Power Steering System – Revised  
Hose Clips on Reservoir-to-Pump Hose

MODEL 1995-96 MY  
Sedan (4.0L) Range  
VIN 720001-776646

ILLUSTRATION 1

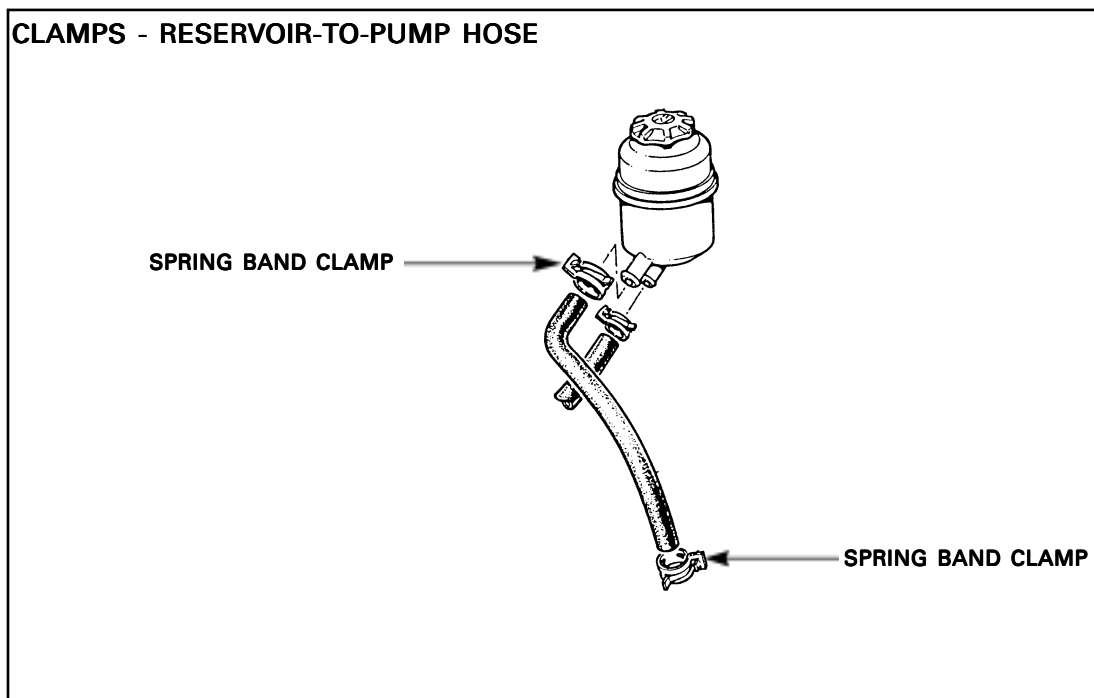
On 1996 MY 4.0L Sedan Range vehicles from VIN 776647, the specification of the hose clamps that retain the hose leading from the power steering reservoir to the power steering pump has been revised.

The spring band style clamp is now replaced by a worm drive clamp at each end of the hose (Illustration 1). This change provides an increase in clamping load, to overcome concerns of hose joint leaks, particularly at the connection to the pump.

Only in the case of a customer complaint of fluid leakage at either point on 1995-96 MY Sedan Range vehicles from VIN 720001-776646, replace the existing spring band clamp with a worm drive clamp (JHC 400401).

Torque the worm drive clamp to 3.5 Nm (31 lb. in.)
